Agenda Item #10

Application 2025-56-CA

Remove 2 historic chimneys

Subject: Evaluation and Recommendation for Potential Chimney Removal

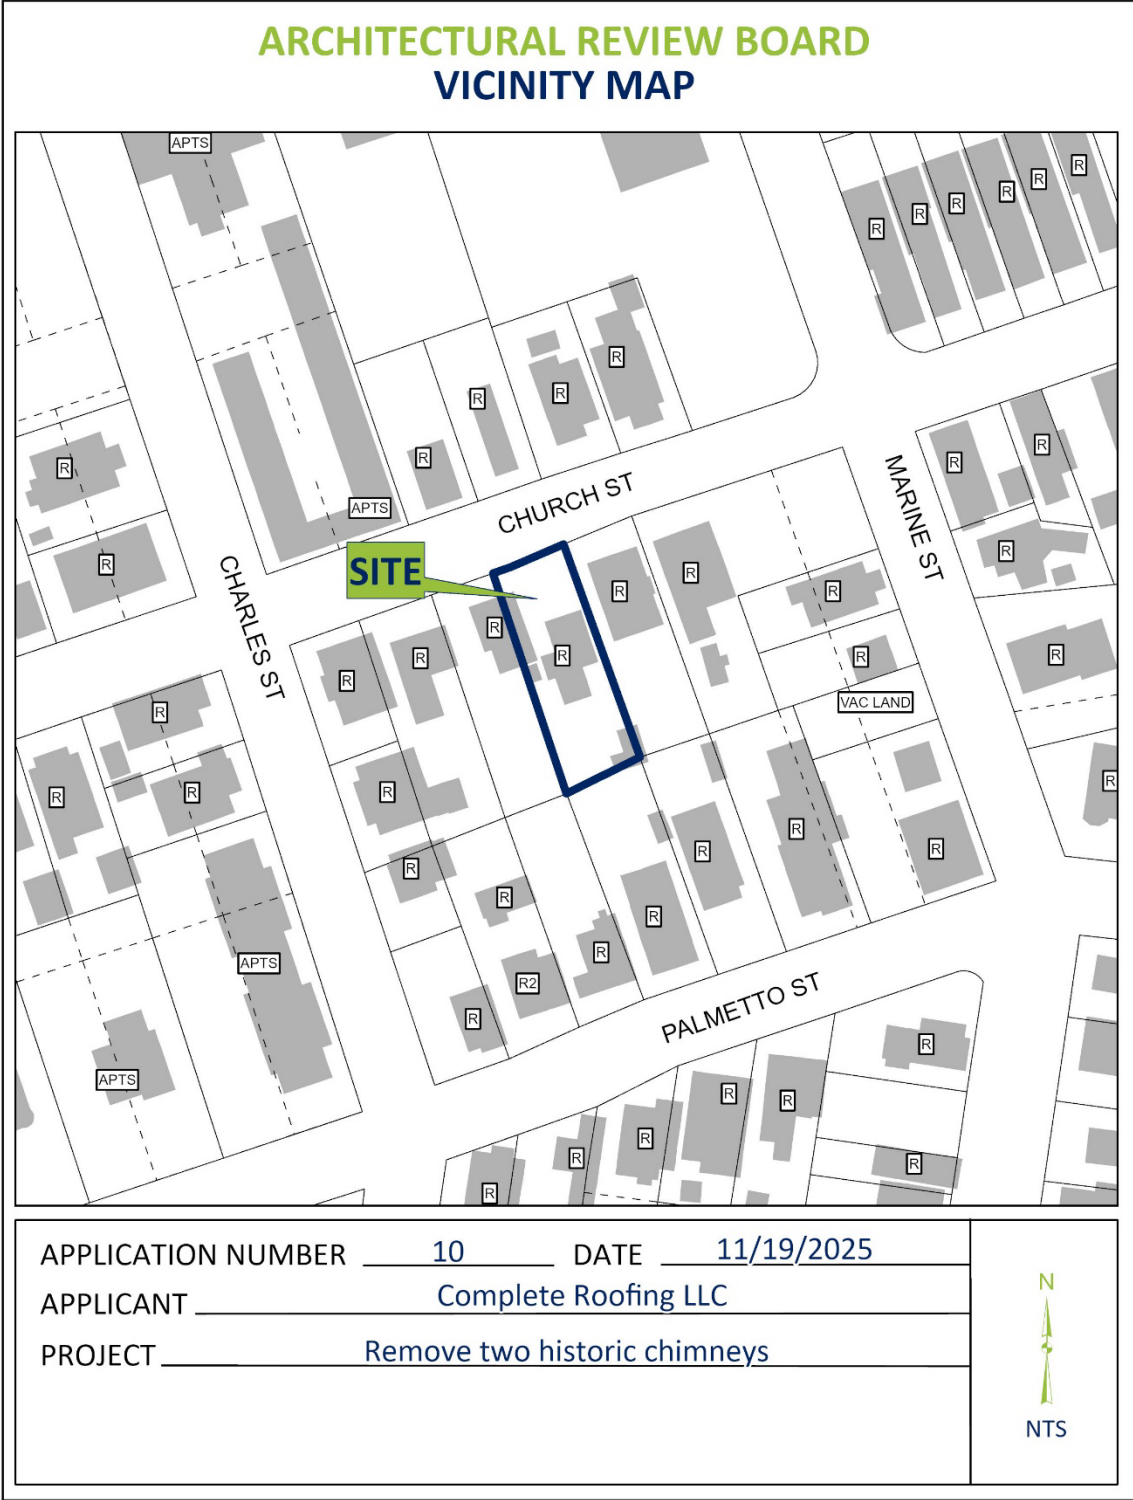
The subject property is a contributing structure to the Oakleigh Garden Historic District. The proposed project includes the removal of 2 chimneys that are located on the west and east elevation.

The *Guidelines* dictate to, “preserve decorative elements, including crests and chimneys” (5.10). The applicant has expressed concern about the structural integrity of the 2 chimneys and has submitted a structural review of them. The review discusses the severity of deterioration that was observed including crumbling and spalling of the exposed brick-and-mortar joints on the eastern chimney, (chimney 1). Much of chimney 1 is covered by a thin concrete like material likely applied to seal off cracking and water intrusion. Chimney 2, on the western elevation, also expressed spalling of the brick-and-mortar joints. Additionally, chimney 2 exhibits severe mortar deterioration, especially near the roof decking and the mortar joints are recessed approximately 1” from the face of the brick, which was noted as an indication of advanced loss of mortar and structural strength.

The *Guidelines* say to, “preserve original building materials” and to only remove materials that are deteriorated and beyond reasonable repair (5.4). The submitted documentation reveals the chimneys to be in a precarious condition and would most likely qualify as being beyond reasonable repair. The applicant has expressed their

preference to preserve the chimneys if possible, but has noted that there is high likelihood that the chimneys could become destabilized during the flashing installation process due to the comprised integrity of the brick and mortar.

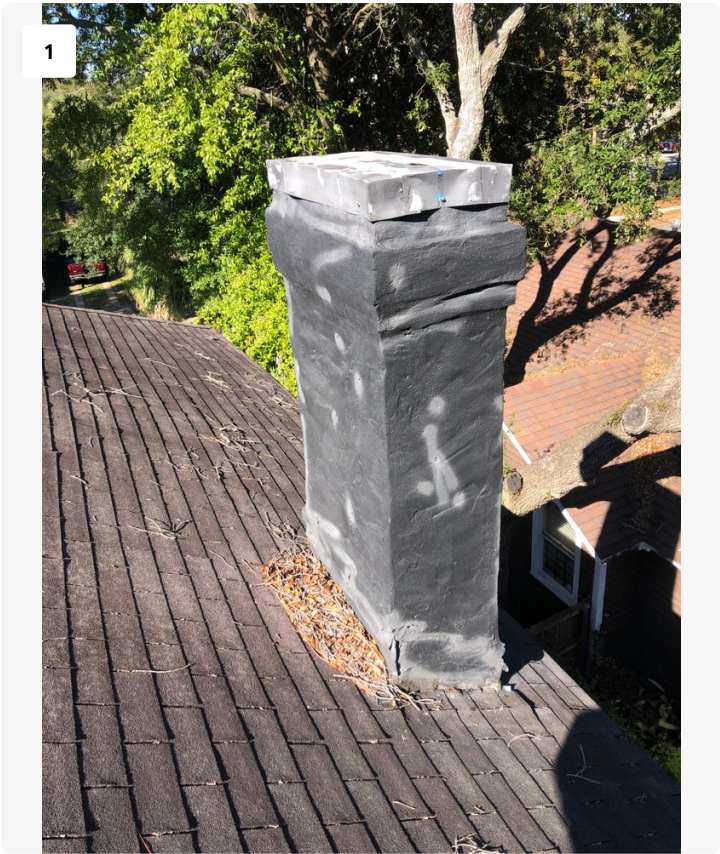
Chimney is in very bad shape and needs to be removed below the roofline.

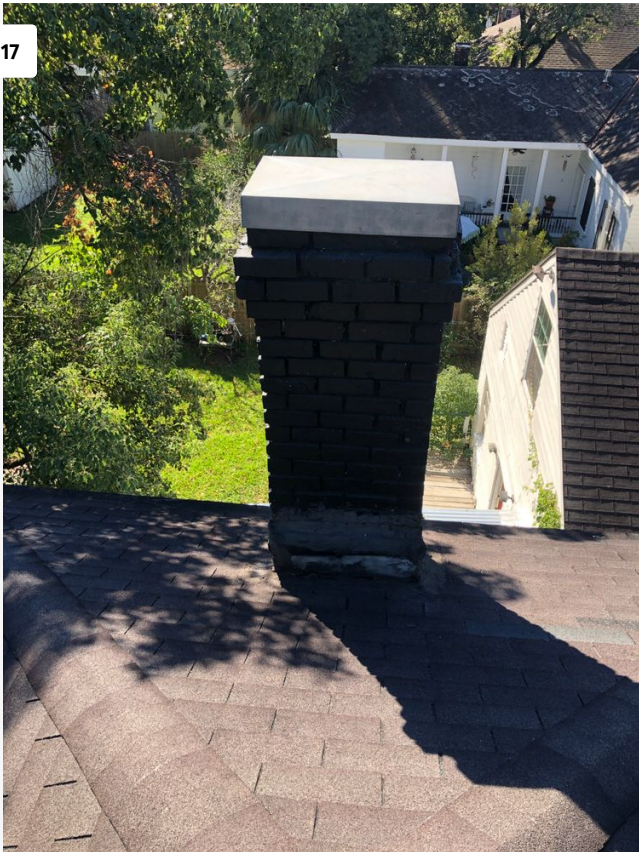
This chimney is permanently capped and serves no purpose also.
